Applies To: **2005 TL with Navigation** – From VIN 19UUA6...5A000001 thru 19UUA6...5A030286

September 3, 2005

Product Update: DTC B1161 with Outside Air Temperature Displays Three Dashes (---), or Intermittent Dead Battery

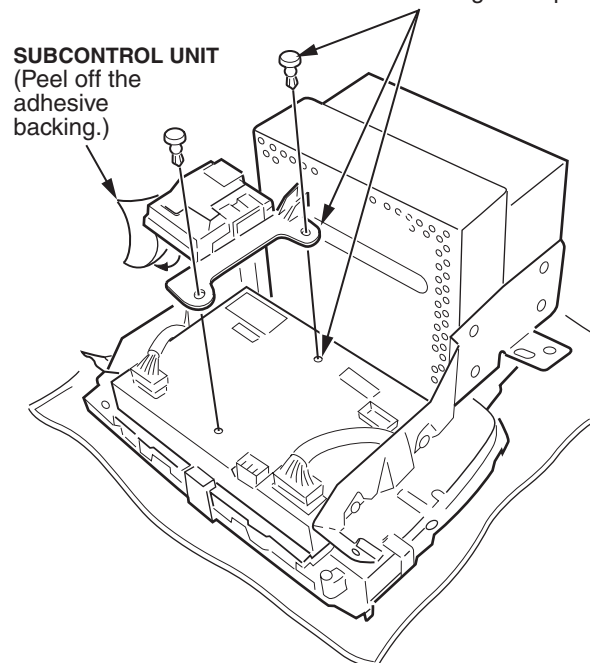
10. Peel off the adhesive backing, but do not attach the subcontrol unit until you have lined up the two small locating push clips in the holes. Once the clips are aligned, attach the subcontrol unit to the display, then push on the clips to lock them into the display.

Align the holes in both the sub-control unit and the navigation unit screen before installing the clips.

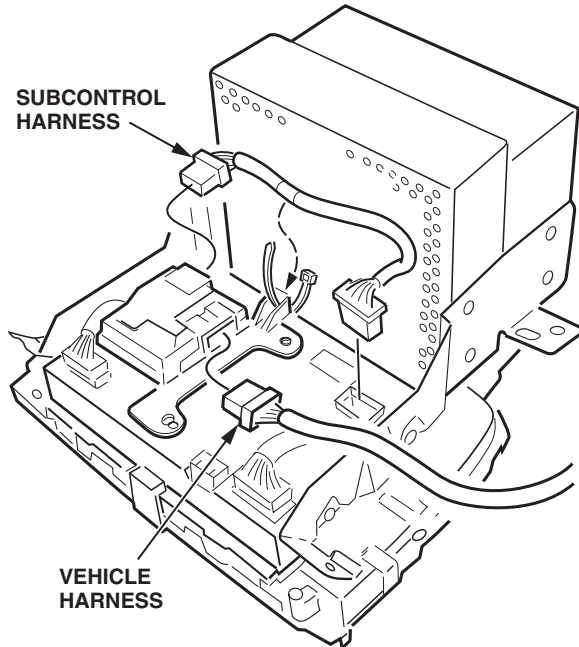
11. Connect the subcontrol unit to the navigation display:
 - Connect the vehicle harness 14P connector to the subcontrol unit connector marked **"FROM VEHICLE."**
 - Connect the subcontrol harness to the connector on the subcontrol unit marked **"TO CPM."**
 - Connect the subcontrol harness to the navigation display.
 - Use a wire tie to secure the subcontrol harness to the subcontrol unit.

NOTE: The 14P connector is unique and will only plug into one location on the navigation display.
